SUBJECT: SOUTH TEXAS PROJECT, UNITS 1 AND 2 - STAFF ASSESSMENT OF INFORMATION PROVIDED PURSUANT TO TITLE 10 OF THE *CODE OF FEDERAL REGULATIONS* PART 50, SECTION 50.54(f), SEISMIC HAZARD REEVALUATIONS FOR RECOMMENDATION 2.1 OF THE NEAR-TERM TASK FORCE REVIEW OF INSIGHTS FROM THE FUKUSHIMA DAI-ICHI ACCIDENT (TAC NOS. MF3935 AND MF3936)

Enclosure:  
Staff Assessment of Seismic  
Hazard Evaluation and Screening Report

STAFF ASSESSMENT BY THE OFFICE OF NUCLEAR REACTOR REGULATION

SOUTH TEXAS PROJECT, UNITS 1 AND 2

Figure 3.2-1 Plot of Staff's and Licensee's Base Rock Mean Hazard Curves at a Variety of Frequencies for the South Texas Project site

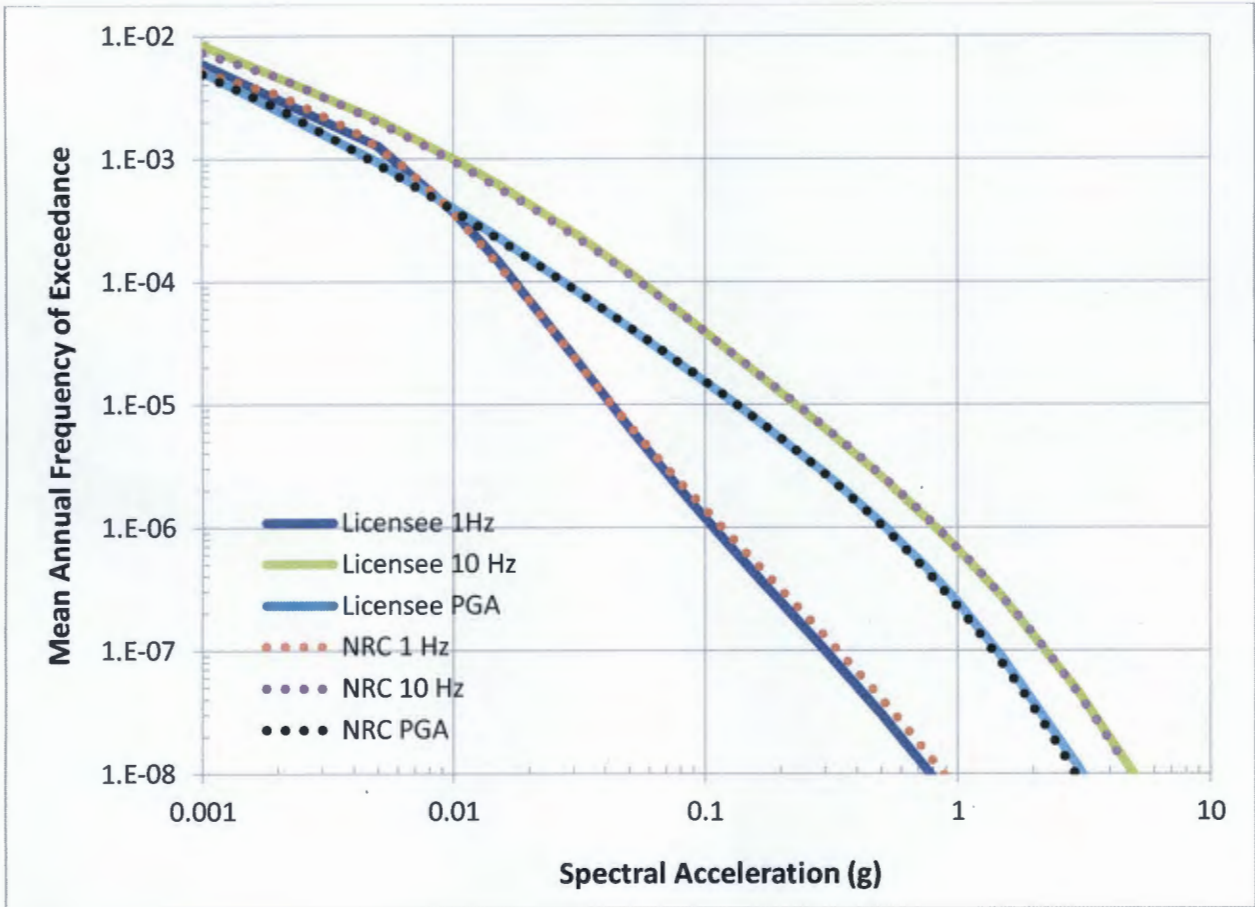
Figure 3.2-1 of this assessment shows a comparison of the licensee's and the staff's base rock seismic hazard curves at 1, 10, and 100 (PGA) Hz. As shown in Figure 3.2-1, the licensee's and the NRC staff's base rock hazard curves are similar, which indicates that differences in licensee's and staff's PSHA inputs had little impact on the results.

Figure 3.3-1 Plot of Staff's and Licensee's Base Case Shear-Wave Velocity Profiles for the South Texas Project site

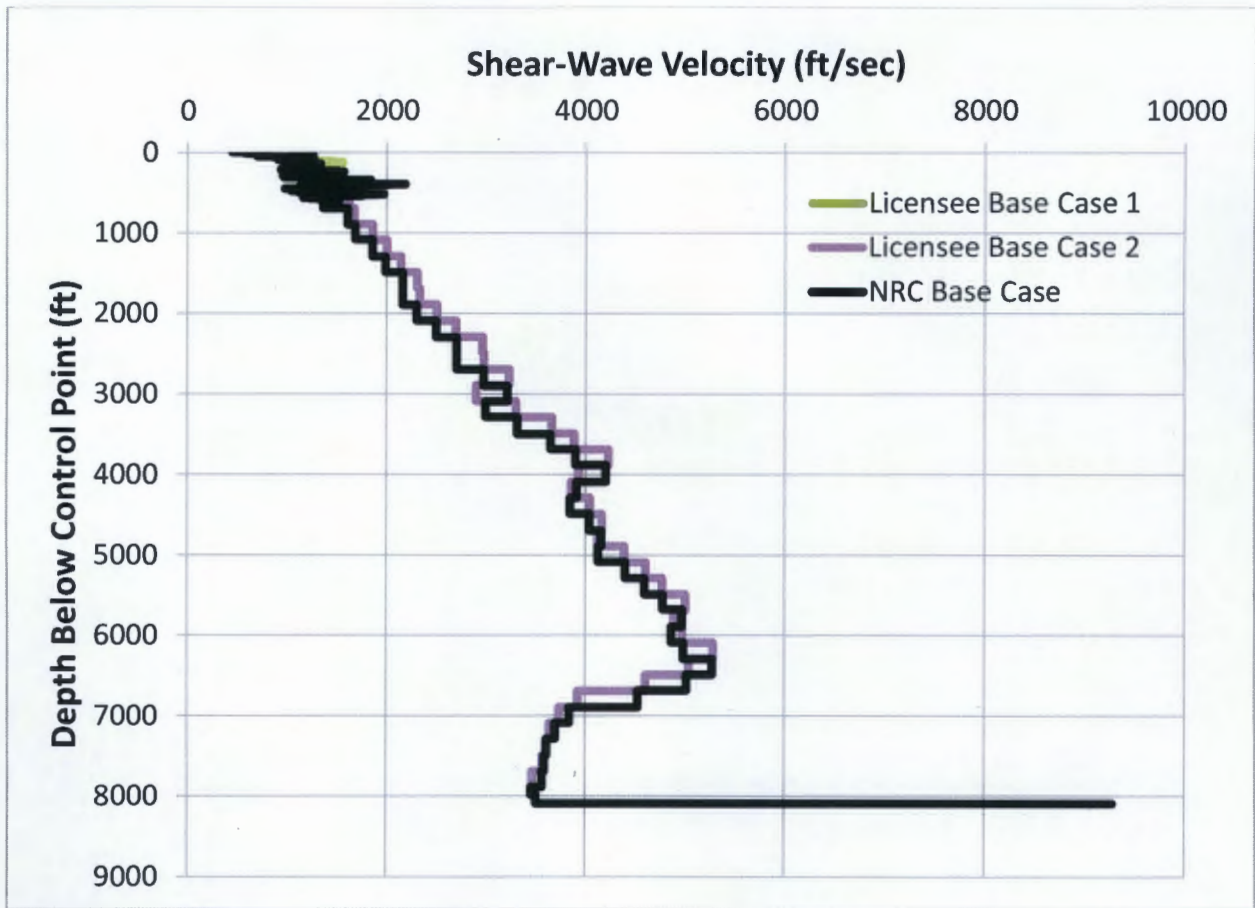
Because the site is well characterized and the velocities reported in the UFSAR for STP, Units 1 and 2 and proposed STP, Units 3 and 4 are similar, the NRC staff used only a single shear wave velocity profile rather than the two profiles used by the licensee. For the depth interval between the control point and the base of the profile, the NRC staff used the shear-wave velocity profiles in the FSAR for the proposed STP, Units 3 and 4 (STP, 2014). This profile is based on the recent data collected at the STP site and is consistent with data from the STP Units 1 and 2 UFSAR (STP, 2010), indicating that the site is relatively uniform. Figure 3.3-1 of this assessment shows the NRC staff velocity profile compared to the base case profiles developed by the licensee.

Figure 3.3-1 Plot Comparing the Staff's and the Licensee's Median Amplification Functions and Uncertainties for the South Texas Project site

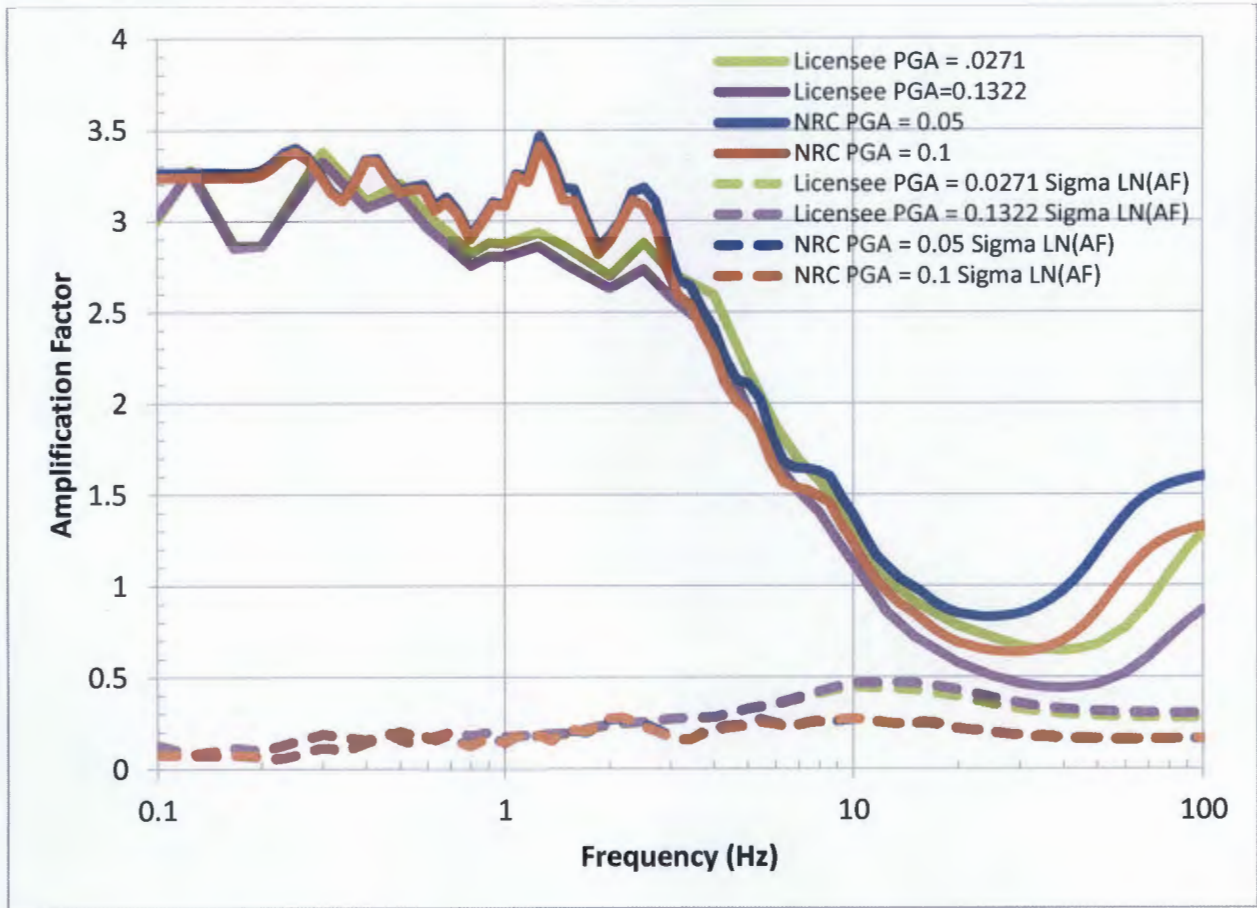
Figure 3.3-2 of this assessment shows a comparison of the licensee's and NRC staff's median site amplification functions and uncertainties ( $\pm 1$  standard deviation) for two input loading levels. Amplification functions developed by the NRC staff are generally higher than those developed by the licensee across the frequency range of interest. However, these differences are small and do not substantially effect the hazard results as shown below in Figure 3.3-3, which shows the licensee's and staff's control point hazard curves for STP.

Figure 3.4-1 Comparison of the Staff's GMRS with Licensee's GMRS and the SSE for the South Texas Project site

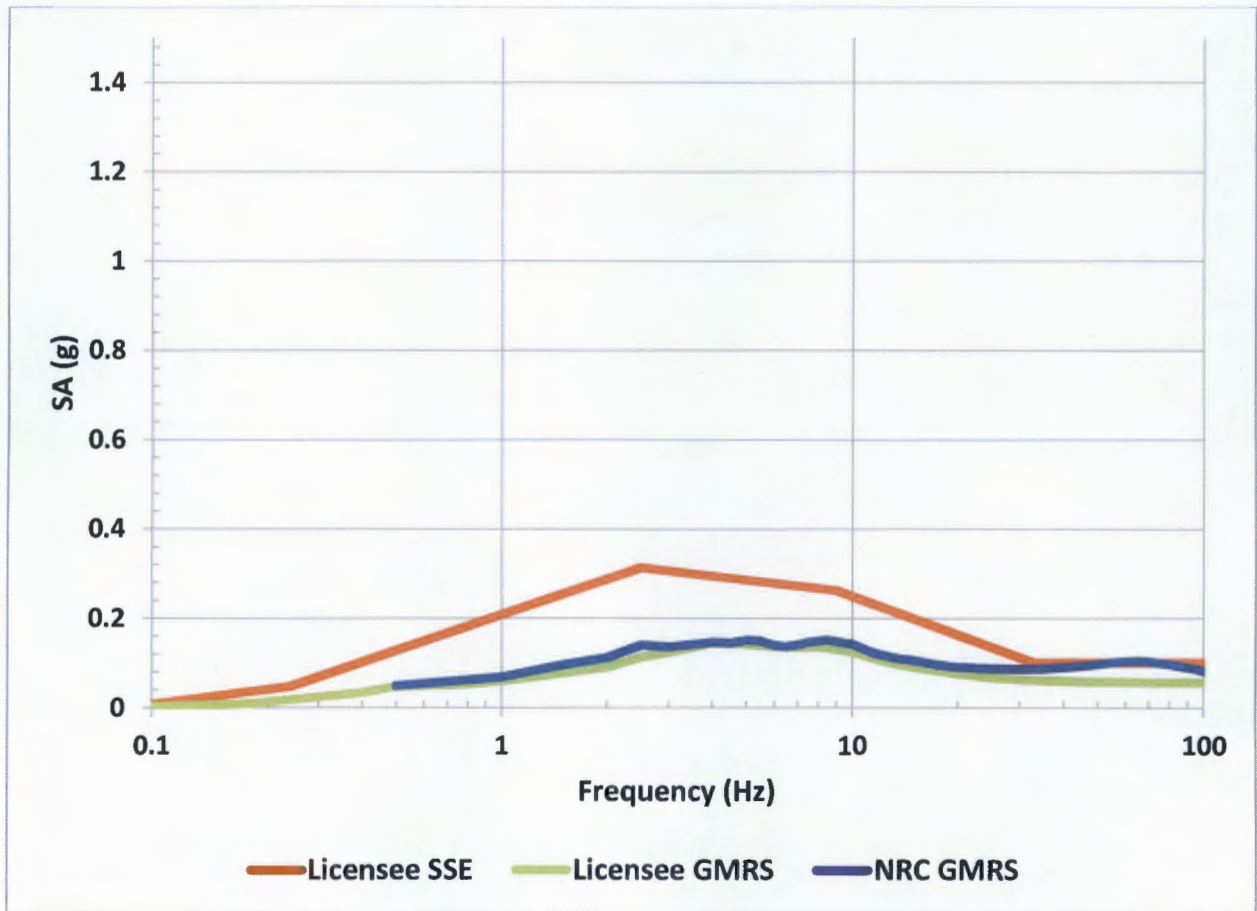
The NRC staff independently calculated the  $10^{-4}$  and  $10^{-5}$  UHRS using the results of its confirmatory PSHA and site response analysis, as described in Sections 3.2 and 3.3 of this staff assessment, respectively. Figure 3.4-1 of this assessment shows a comparison of the GMRS

determined by the licensee to that determined by the NRC staff. As shown in Figure 3.4-1, the licensee's GMRS shape is very similar to that calculated by the NRC staff.
